SUBJECT: Subcontract S005242-F

Dispositioned Request for Deviation (RFD) 14-019

Attached for your information and appropriate action is NCSX Project dispositioned RFD 14-019 initiated by Mike Griffith for "Adding Lifting Holes in Poloidal Break Shims."

NCSX RFD Number: 14-019 Part I		RFD Description: Adding Lifting Holes in Poloidal Break Shims		
Initiator: Mike Giffith	Organiza	Organization: MTM		
List of Impacted Documents: (Specification, MIT/QA Plan, SOW, drawing, etc.) • SE141-048 (MC Poloidal Break Shim Assembly Type-A) • SE141-058 (MC Poloidal Break Shim Assembly Type-B) • SE141-078 (MC Poloidal Break Shim Assembly Type-C)				
Cost Impact: (If none, so state): NONE Schedule Impact: (If none, so state: NONE				
Quality Impact: (If none, so state): Incorporation of these proposed changes will improve MTM manufacturing processing of remaining MCWFs not yet shipped.				
State Requirement Deviation is Requested For: (Specification, MIT/QA Plan, SOW, drawing, etc.): Revise identified drawings to provide lifting holes in Poloidal Break Shims.				
Full Description of the Deviation Requested: (Use continuation pages, e-mails, letter, sketches, etc. as needed and include amplifying

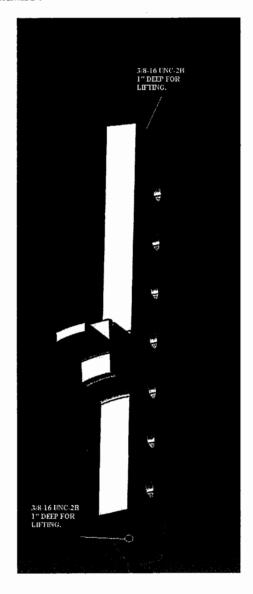
In order to assist in the intermediate and final assembly of the poloidal break shims in the remaining C's and in all of the A and B shims, we are requesting the addition of a 3/8-16 hole in both ends of the shim to be used for lifting. The drawing below is a C shim showing the approximate location of the holes. Please review and forward this request to PPPL. Thanks.

The lifting holes would be incorporated into C6 and all of the A and B shims. C5 is beyond this. Thanks.

NCSX RFD N	lumber: 14-019	RFD Descrip Poloidal Bre	ption: Adding Lifting Holes in ak Shims		
Part III		2 0.0144.1 2.10			
RLM: Brad Nelson		Organization: ORNL			
Impact on Interfaces with Other WBS Elements/Items: (If none, so state): NONE					
RLM Recommendation:					
Additional remarks:					
No drawings will be changed – stamp will be added to pdf drawing to reflect this RFD.					
Does this Change Impact Material Already Procured or Parts/Assemblies Already Assembled/Manufactured using this Material: Yes No If "Yes", what is the recommended disposition of this material/part/assembly? C Castings already shipped will not be changed (C1 through C5) and will be used as is. Remaining castings will reflect this change.					
RLM Signature: Bra	ad Nelson	Digitally agreed by Brad Melaon DK: cn=Brad Melaon, crtdS, cnOfNL, ounFED, email-melaon gor Deat: 2006 04.13 17:43:18 -04'00'	èn gorri.		
Project Disposition:

Approved. No ECP required.					
	E	Sob Simmons	Digitally signed by Bob Simmons DN: cn=Bob Simmons, c=US Reason: I have reviewed this document Date: 2006.04.13 09:15:51 -04'00'		
	1	NCSX Systems Engine	ering Support Manager		
Approved. ECP will be assigned and processed.					
☐ Not Approved. Reason(s) for disapproval:
